THE OFFSHORE OIL AND GAS EXPLORATION, PRODUCTION, UNLOADING AND STORAGE (ENVIRONMENTAL IMPACT ASSESSMENT) REGULATIONS 2020

**Applicant provision of Further Information in response to
Notice under Regulation 12(1) sent to LB CCS Limited on
1st July 2024.**

Figure 2.1: Location of Proposed Development components and the Wales/England territorial boundary and existing infrastructure

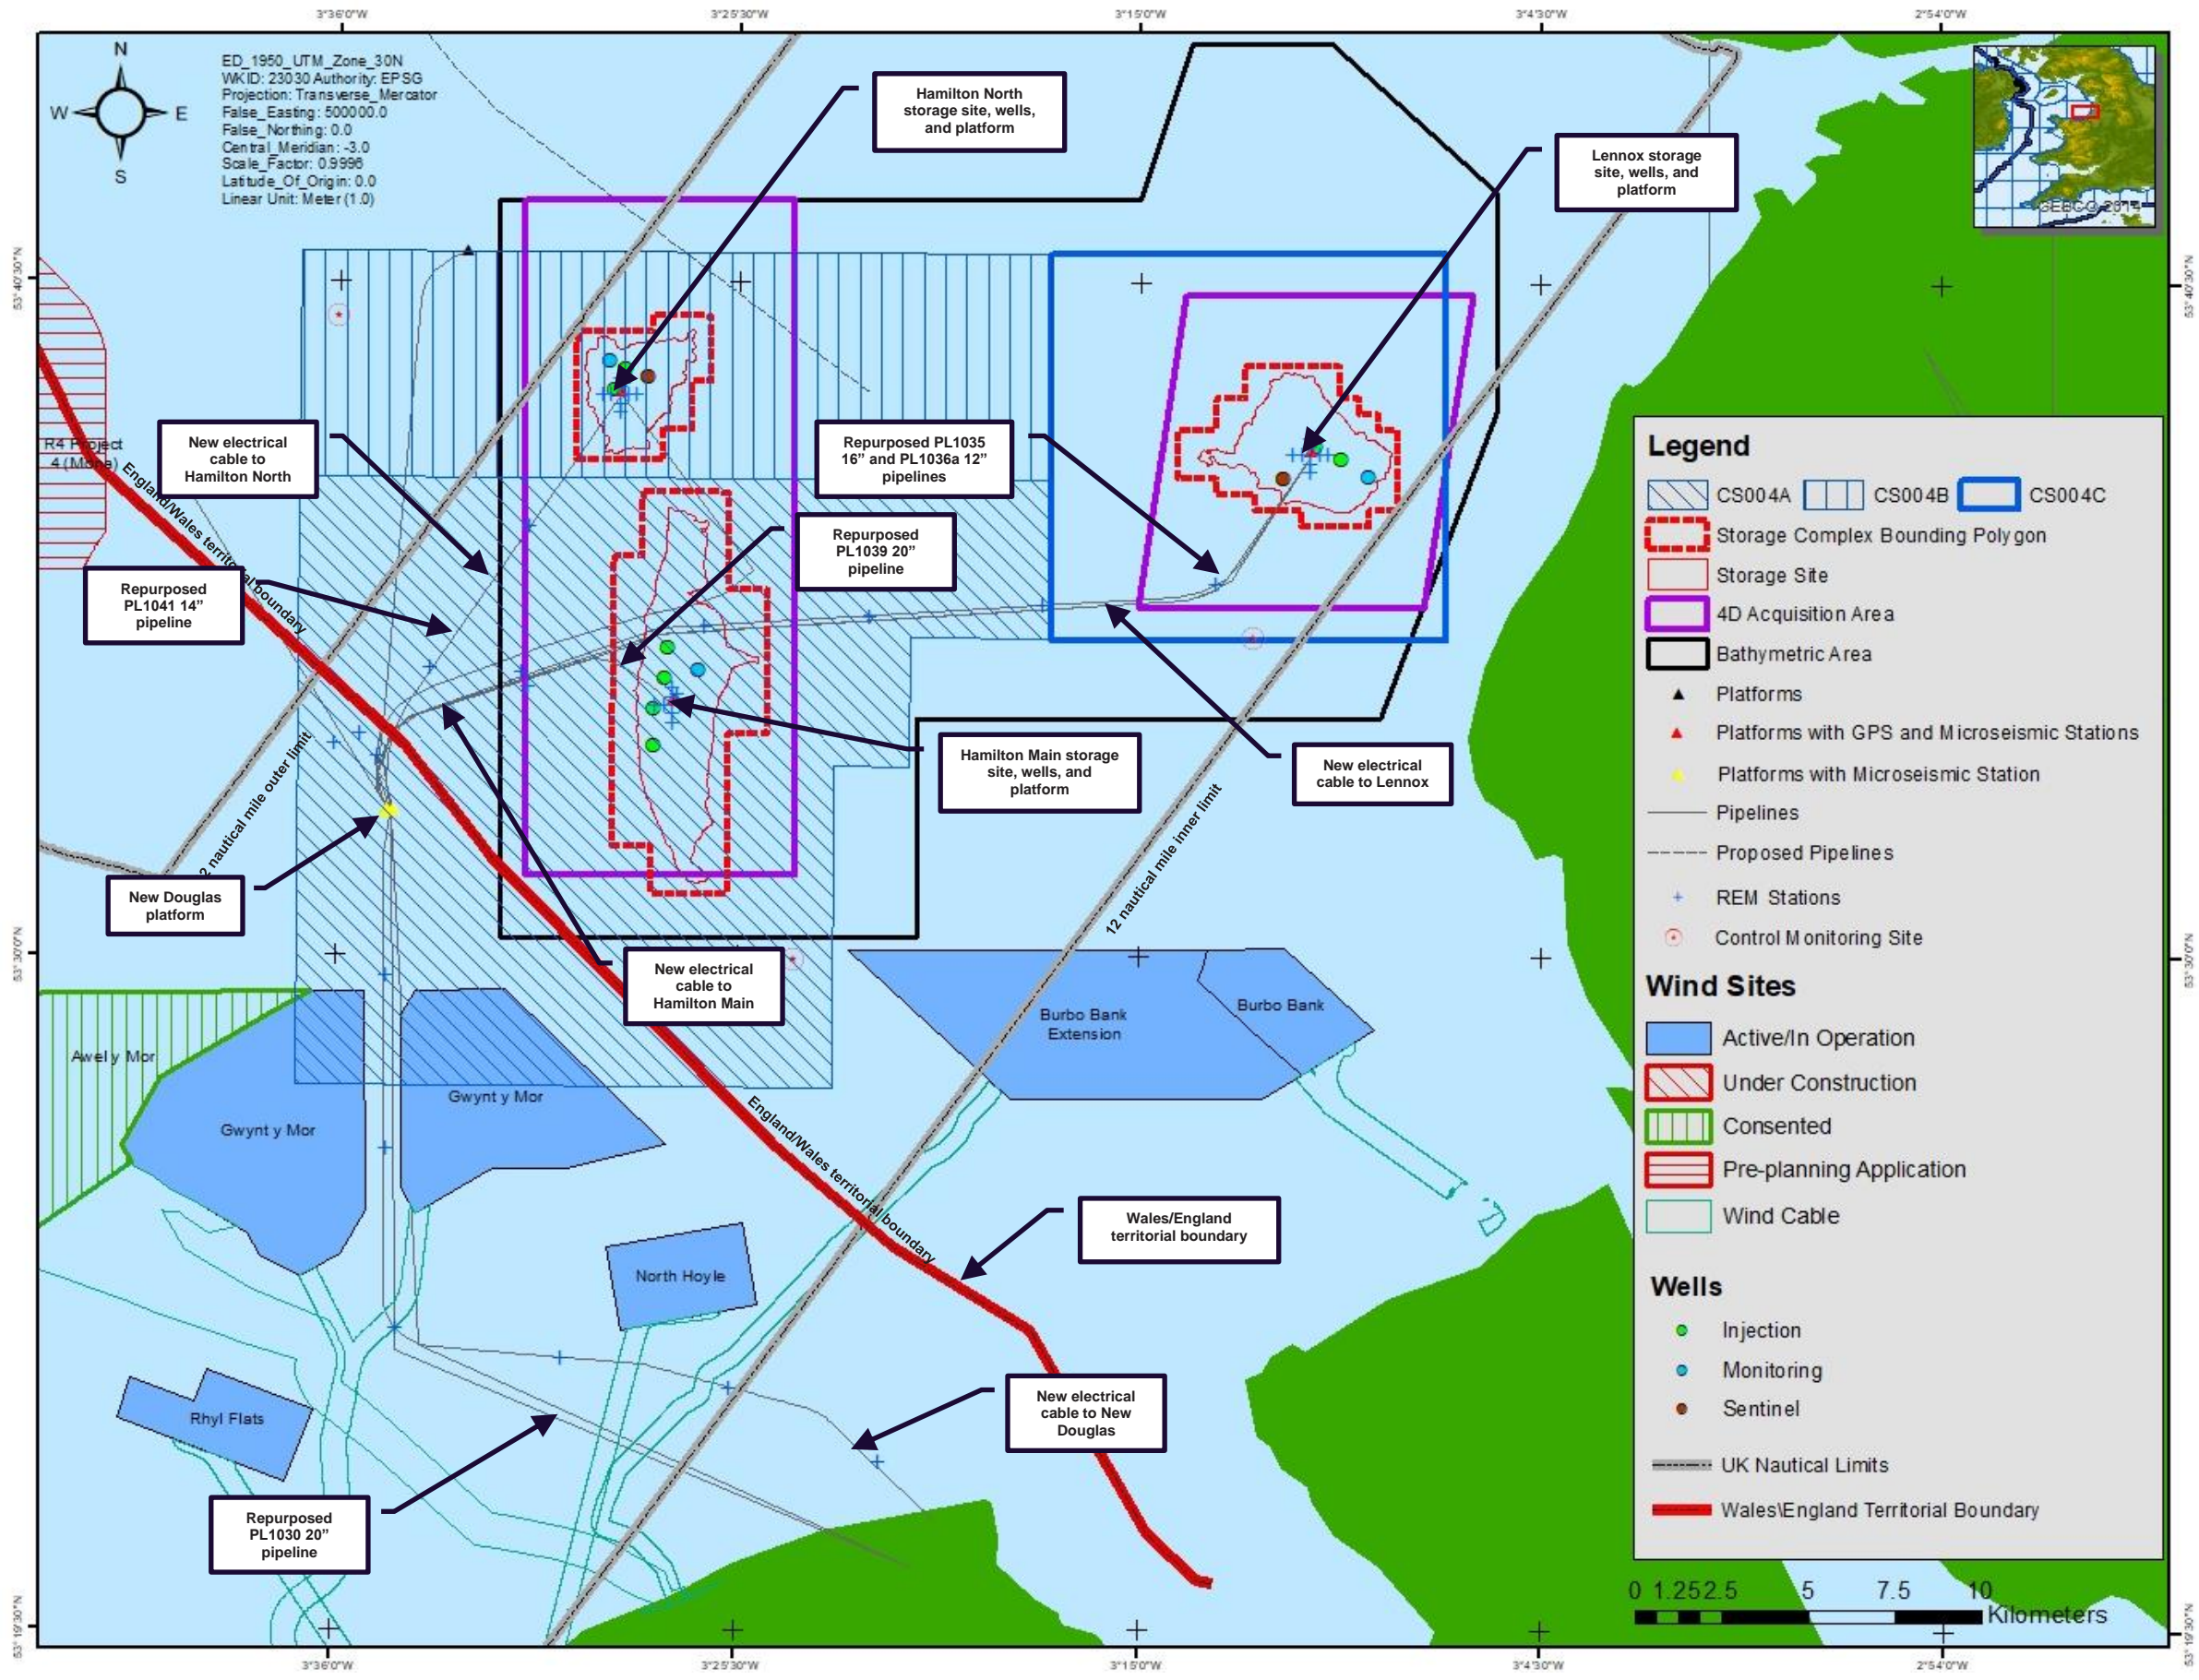
OPRED's previous comments in Regulation 12(1) letter dated 1 July 2024, requested a clear delineation of the boundaries of the project. Whilst it is recognised that Figure 2.1 provides detail on the development area in relation to the Marine Plan region, there is no indication/detail of the Welsh/English territorial boundary. Figure 2.1 provides details for existing infrastructure. Please revise to include the location of proposed new infrastructure, including pipelines and cables and their proximity to the Welsh/English boundary. In addition, please provide a clear map of the project with respect to all the relevant Marine Protected Areas (MPAs) and the Welsh/English boundary.

Figure 2.1 shows the boundary between English and Welsh territorial waters, which is also the boundary between the England and Wales Marine Plan Areas. The Hamilton Main, Hamilton North, and Lennox storage sites, wells, and NUIs are located within English Territorial Waters. The injection, monitoring, and sentinel wells will be drilled from within the template of the existing platform wells at each of the Hamilton Main, Hamilton North, and Lennox NUIs, which are all within English Territorial Waters.

Figure 2.1 shows that the New Douglas Platform, and new electrical cable from Point of Ayr to the New Douglas Platform are located within Welsh Territorial waters. The new pipeline spools to connect the existing gas pipelines to the New Douglas NUI are located within Welsh Waters at the coordinates presented in **Table 3.5** in response to **Question 3** below.

Figure 3.1: Location of Proposed Development components and the Wales/England territorial boundary and existing infrastructure

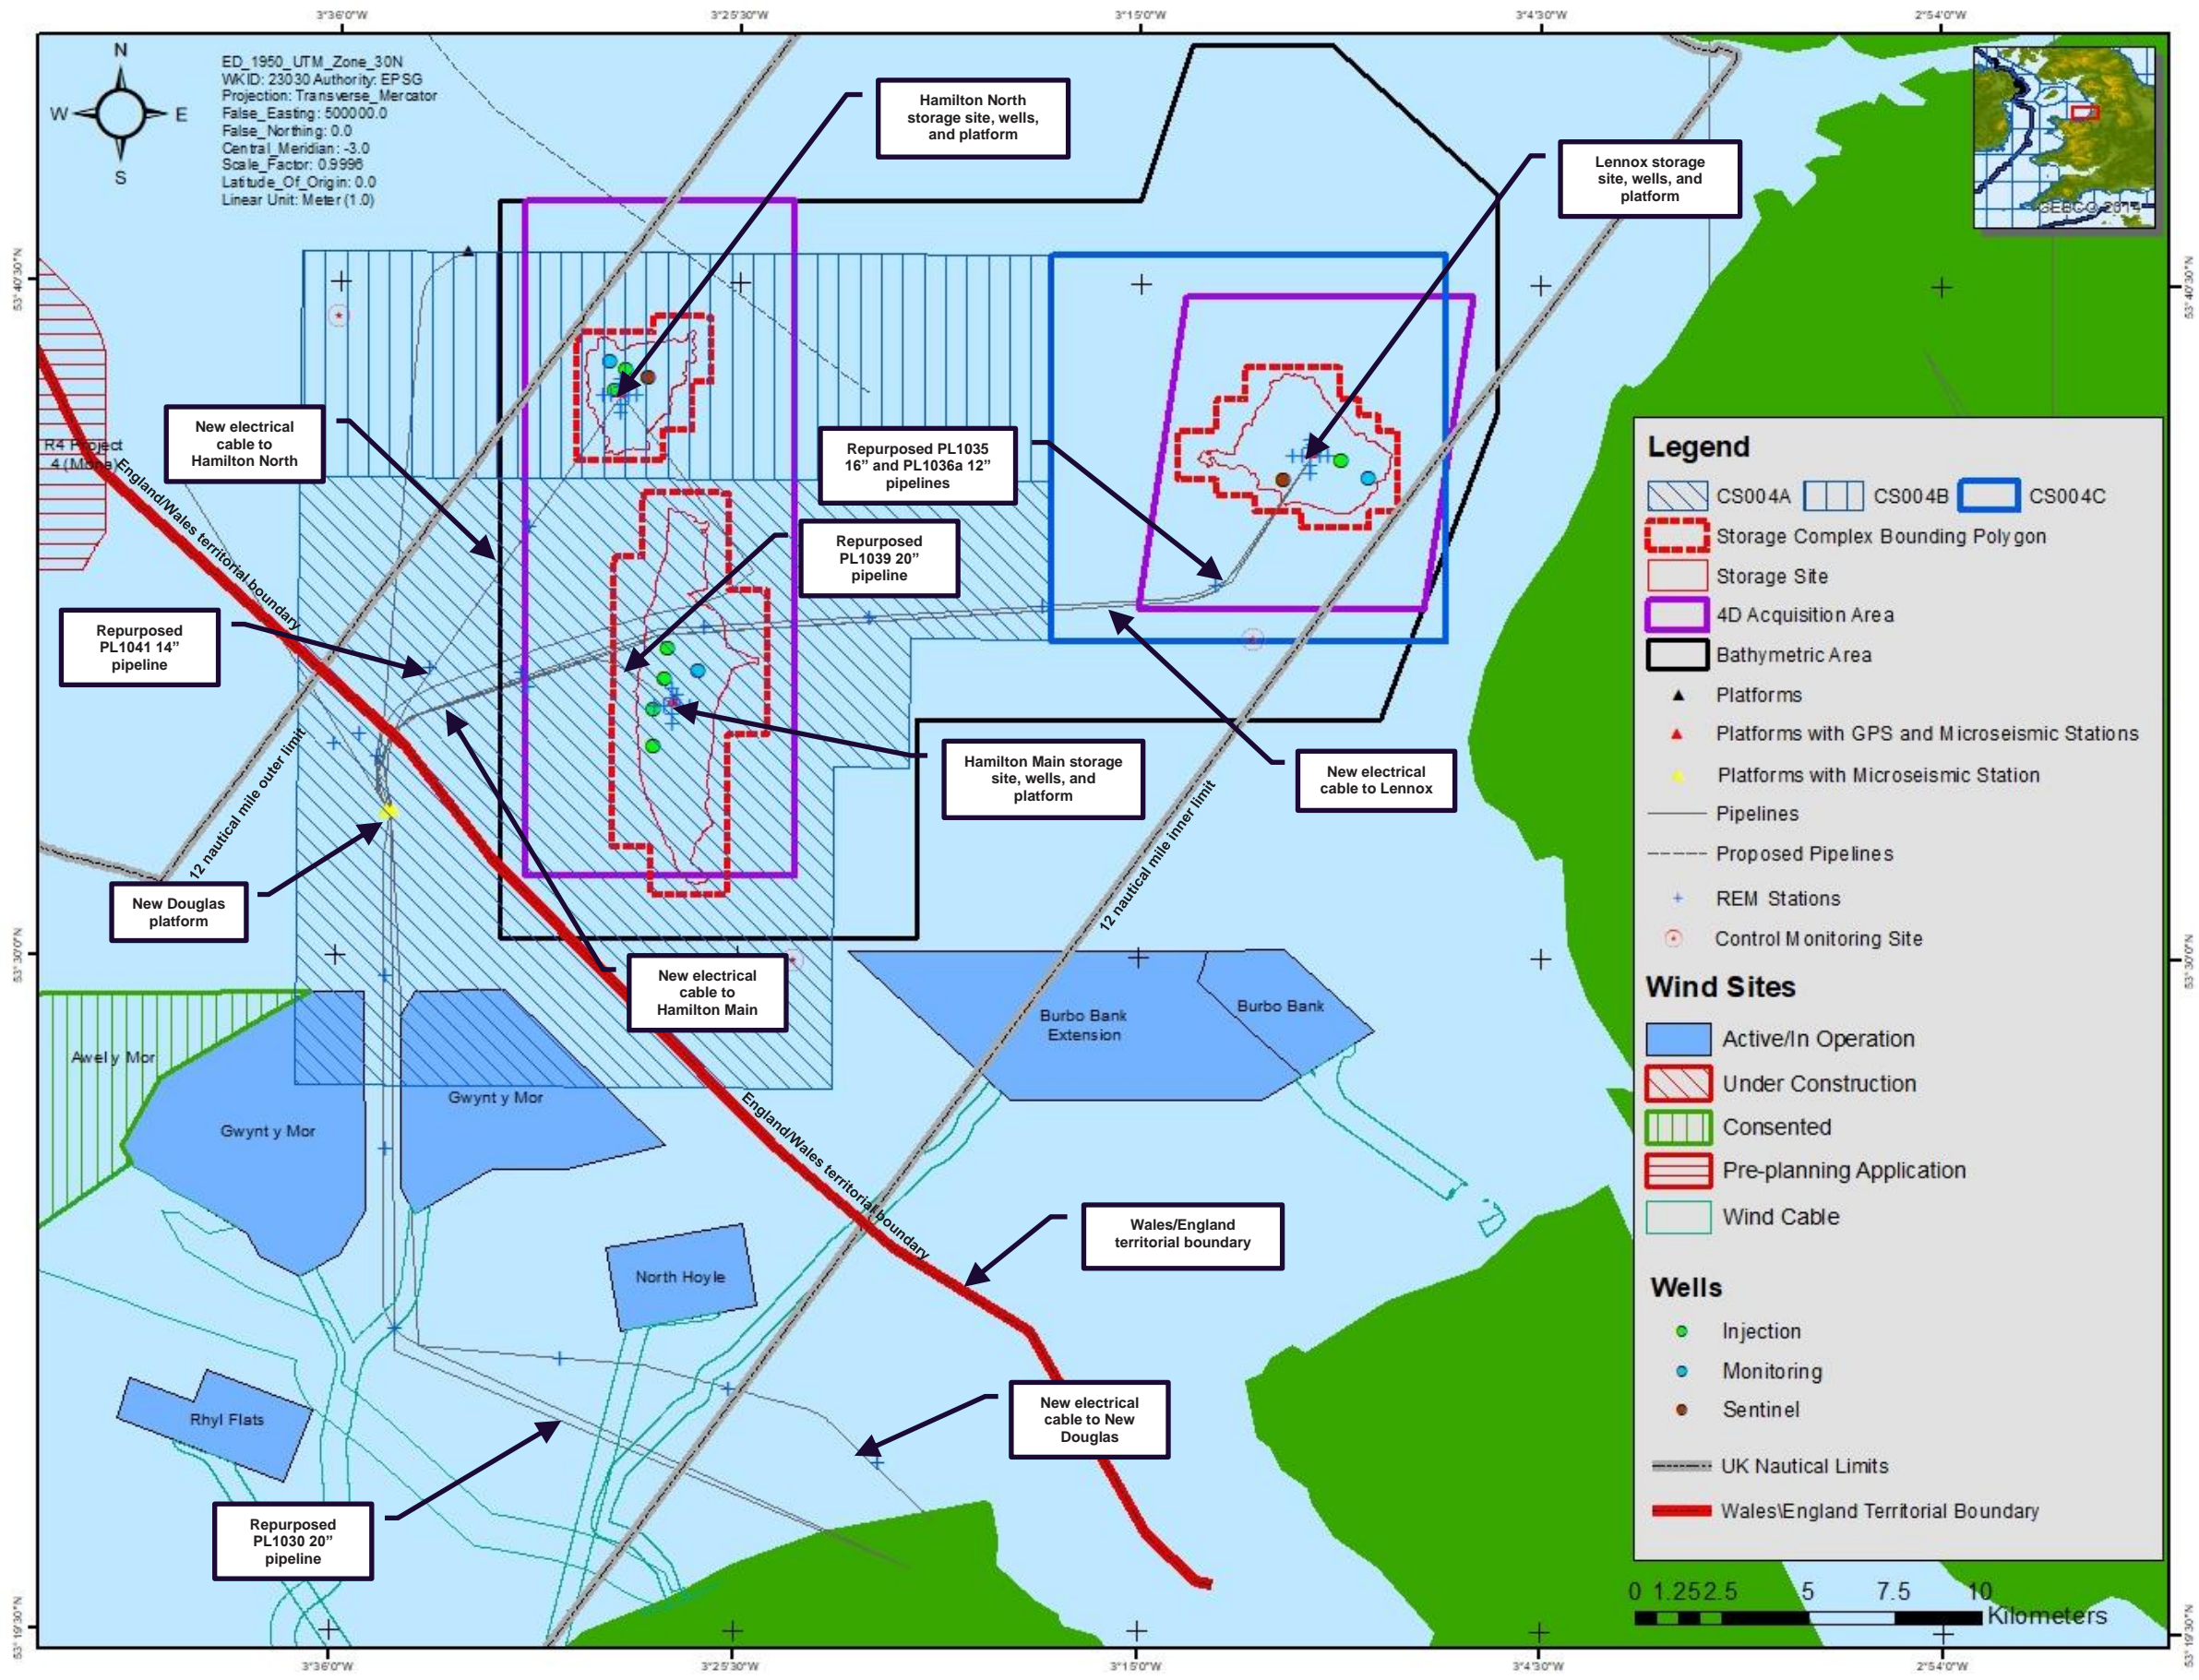
- 8- The entire Proposed Development is within the Liverpool Bay SPA except for the New Douglas platform and the Hamilton North platform as shown on the **Figure 3.1. Table 2.1** presented in response to **Question 2**, presents the distances of the Proposed Development to the different MPA sites.
- 9- The entire Proposed Development is within 12 nm limit of both Welsh and English territorial waters as shown below in **Figure 3.1**.

Figure 3.5: Extract from satellite image illustrating location of boundary between subtidal and intertidal zones and proposed electrical cable route

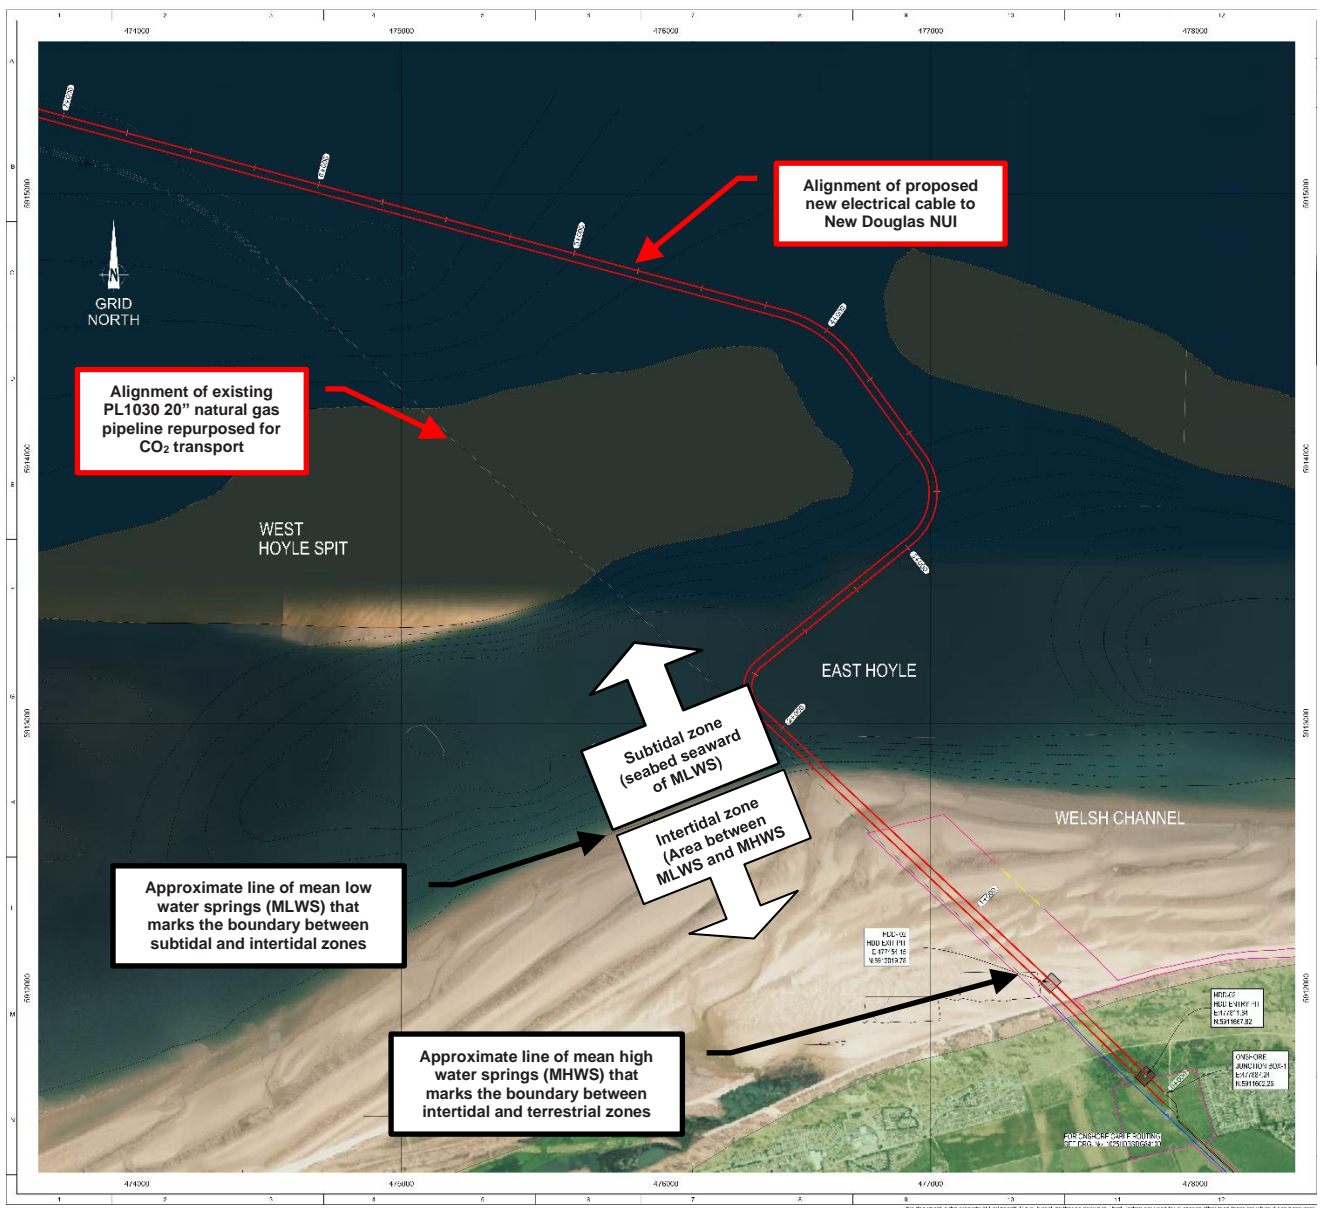
- Please include a figure illustrating where infrastructure (new and existing) is in relation to the different zones (intertidal/subtidal) (which have been used in Chapter 7), so that this can be put into context for the whole project.

Eni Response: Figure 3.5 presents an extract from a satellite image to illustrate the location of the boundary between subtidal and intertidal zones and the proposed electrical cable route. The subtidal zone is defined by the whole seabed, seaward of mean low water springs (MLWS). The intertidal zone is defined by the area between MLWS and mean high water springs (MHWS). Also shown is the alignment of the existing PL1030 natural gas pipeline from the Douglas Complex to the Point of Ayr terminal. For context, Figure 3.6 presents an extract from the relevant Admiralty Chart information, also illustrating the location of the boundary between subtidal and intertidal zones, and the alignment of the existing PL1030 natural gas pipeline from the Douglas Complex to the Point of Ayr terminal.
